## IDAP REPORT

<b>Property:</b>	14 Howard Street, Strathfield Lot 10 DP 12405 DA2021/285
<b>Proposal:</b>	Demolition of existing structures, construction of a two (2) storey dwelling house with basement level, an outbuilding comprising a cabana, storage and a bathroom, and ancillary landscaping.
<b>Applicant:</b>	ES Design
<b>Owner:</b>	P Sleiman
<b>Date of lodgement:</b>	8 November 2021
<b>Notification period:</b>	12 November 2021 to 26 November 2021
<b>Submissions received:</b>	Nil
<b>Assessment officer:</b>	P Santos
<b>Estimated cost of works:</b>	\$1,283,977.00
<b>Zoning:</b>	R2 - Low Density Residential - SLEP 2012
<b>Heritage:</b>	Adjacent to Marion Street Conservation Area "C12"
<b>RECOMMENDATION OF OFFICER:</b>	<b>APPROVAL</b>

Figure 2. Extract of the site plan.

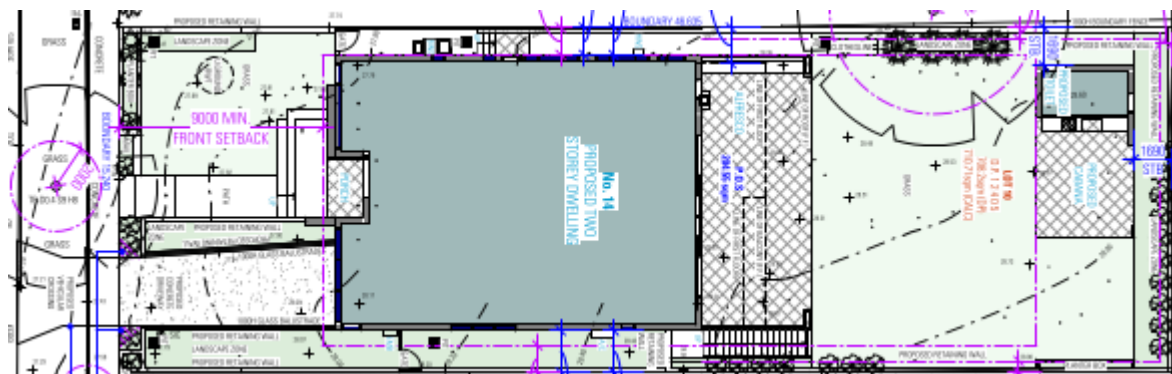
*“...the proposed driveway location needs to be 3.5m from the base of the street tree. Driveway may need to be pushed towards the boundary another 0.5m”*

The driveway is proposed to be 3m away from the trunk of the street tree as per the provided site plan. Due to the works proposed near the street tree only relate to a driveway and are considered minor, a setback of 3m from the street tree is considered to be acceptable and that no further setback is necessary. To ensure the protection of the subject tree, a condition has

been imposed for the driveway to retain its proposed setback by at least 3m from the trunk of the tree and the works relating to the driveway are to be overseen by a suitably qualified arborist.

Figure 3. Extract of the amended basement plan, dated 08/12/2021.

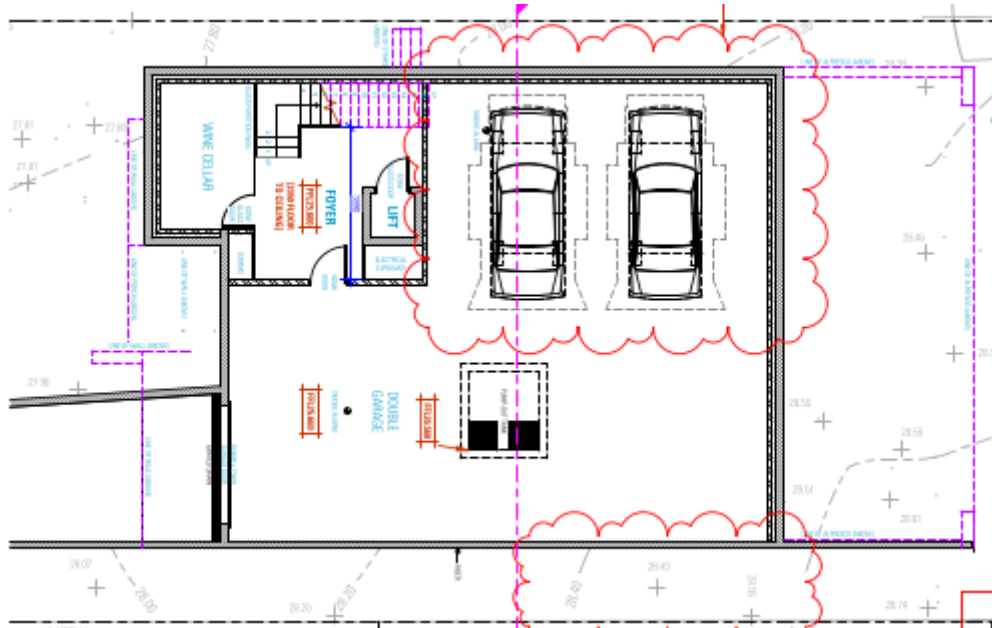
Note that the initial design included external stairs within the southern side boundary of the alfresco that lead to the basement from the ground level, see Figure 2. This was required to be deleted and be removed from the proposal. The applicant has provided an amended basement plan, however, no other amended plans were provided. As such, all other plans still show the external stairs. This can be resolved by a condition of consent requiring the deletion of the external stairs in all of the plans prior to receipt of the construction certificate.

Amendments made in red on approved plans	All changes made in red on the approved plans shall be updated and shown on the Construction Certificate plans.
Basement Blade Wall	The 'blade wall' attached to the south-east of the basement underneath the alfresco is to be deleted.  No external walls to be constructed outside the basement.
Basement External Walls	The southern and western walls of the basement are to have thickness and construction materials similar to that of the eastern and northern external walls.
External Stairs	The external stairs that lead to the basement from the ground are to be deleted.
Driveway – Council Verge	The driveway within Council verge is to be setback at least 3m from the street tree

Figure 18. Extract of the submitted shadow diagrams.

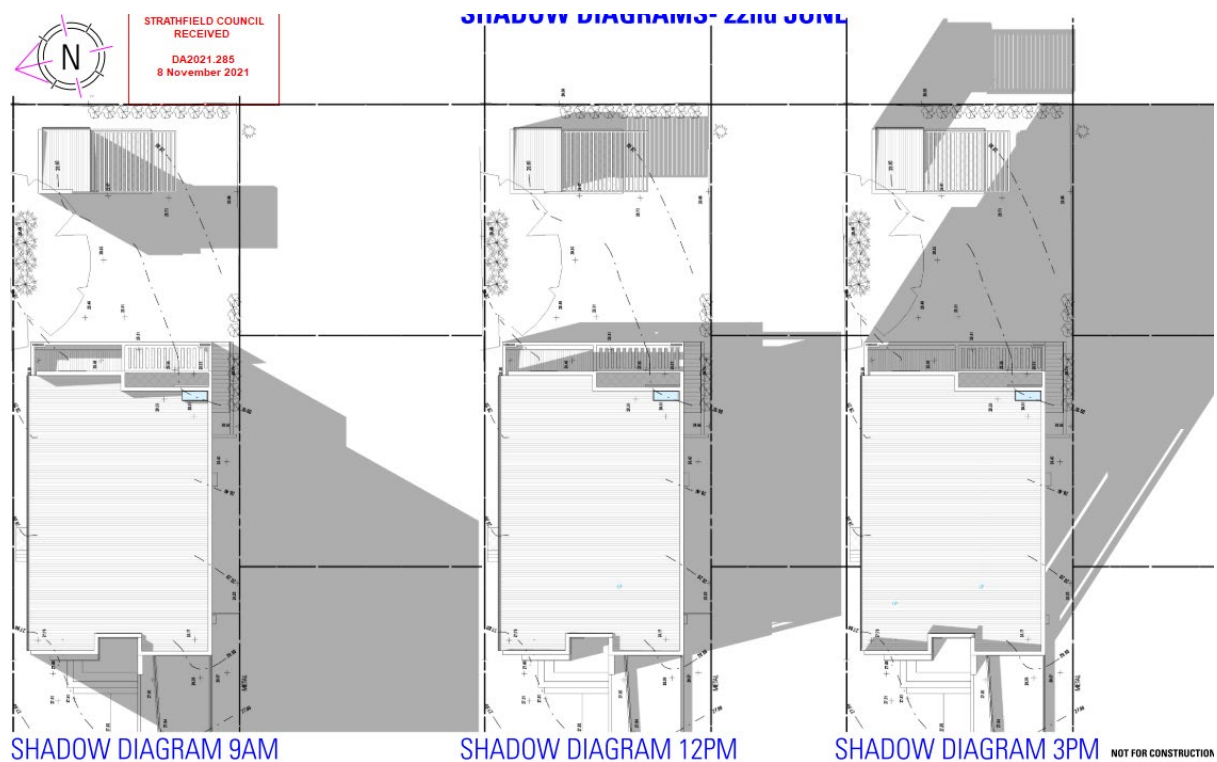
As evident in Figure 18 below, the three southern neighbours are to receive at least 3 hours of sunlight between 9.00am to 3.00pm on winter solstice. As such, it is considered that the solar access requirements of Council are achieved.
